**FORMER SPERRY REMINGTON SITE
(NYSDEC SITE I.D. #808043)**

**REVISED
INTERIM REMEDIAL MEASURE
WORK PLAN**

**Re: Revised Interim Remedial Measures Work Plan
Former Sperry Remington Site #808043
Elmira, Chemung County**

TEST PIT LOCATIONS FORMER SPERRY RECORDS SITE ELMIRA, NEW YORK		FIGURE 4
Cooney & Co. INCORPORATED	PROJECT NO. PRJ-140 MARCH 2019

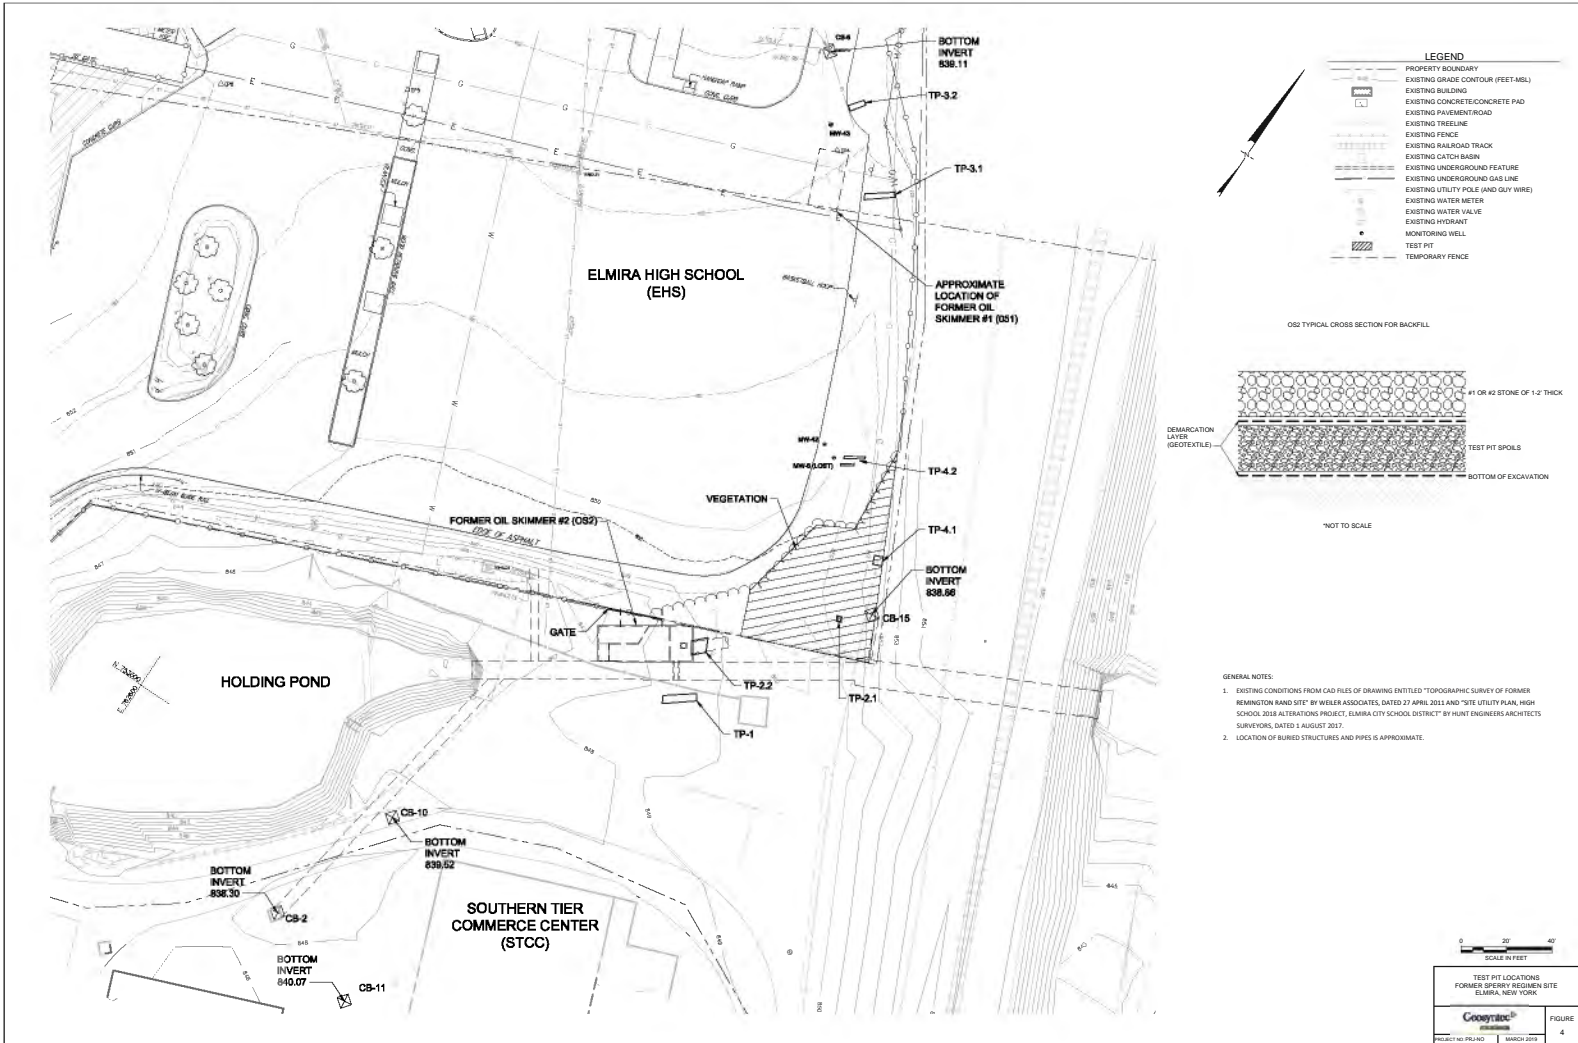
- 6. Update depictions on Figure 4 to be consistent with descriptions and dimensions presented in Section 2.2.2 Test Pit and Trenching. Add typical section for backfill and demarcation in addition to chemical quality data for each pit or trench location and CB-15.*

Response: Accepted. Figure 4 has been revised to be consistent with descriptions and dimensions presented in Section 2.2.2 Test Pit and Trenching. A typical section for backfill and demarcation has been added as well as chemical quality data for each pit or trench location and CB-15.

Figure 20

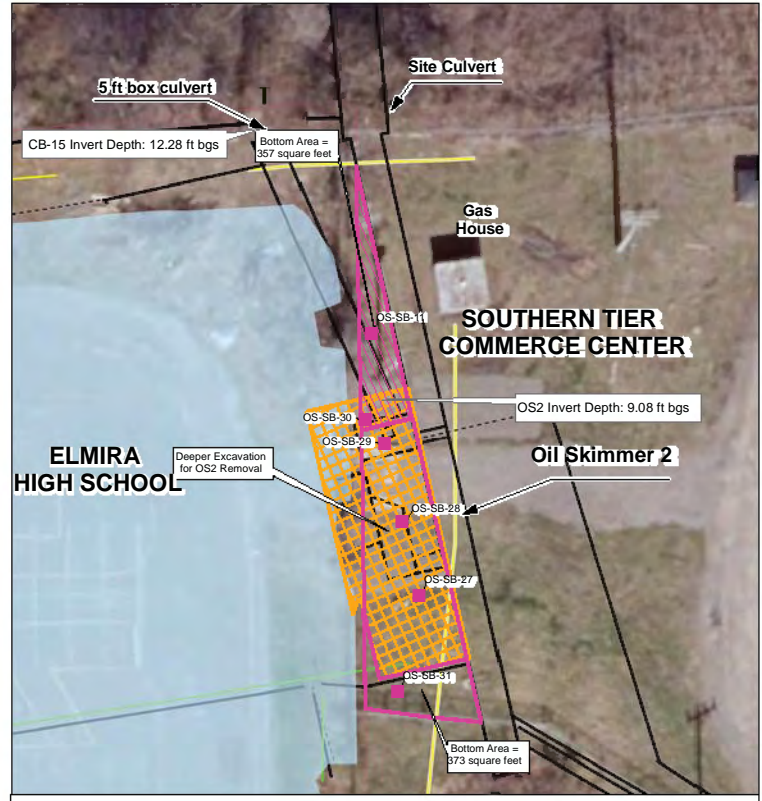
32. *Figure 20 – the proposed excavation 0-2 ft bgs should depict the extent of slope benching necessary to remove OS-2.*

Response: Figure 20 presents the proposed shallow soil excavation to achieve the IRM objectives for soil cleanup at the Site. Sloping of the excavation to remove OS2 will extend onto the EHS property. Soils on the 0-2 ft interval have been previously remediated on that property as part of IRM #2 for the Former Sperry Remington Site – North Portion (#c808022).

OIL SKIMMER #2 PLAN
SCALE: 1" = 10'

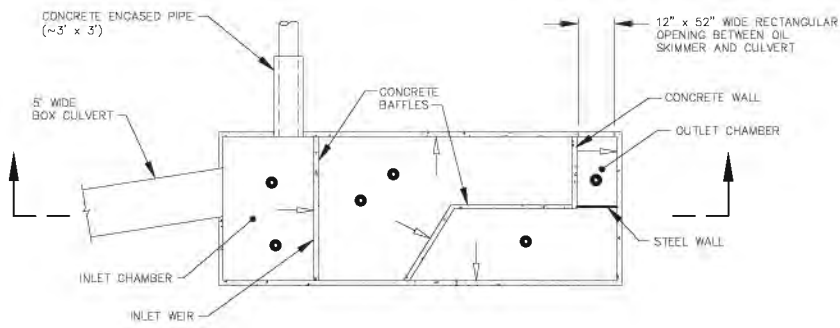
33. *Figure 21 – 3” steel pipes on north edge of OS-2 do not exist.*

Response: The steel pipes have been removed from Figure 21.
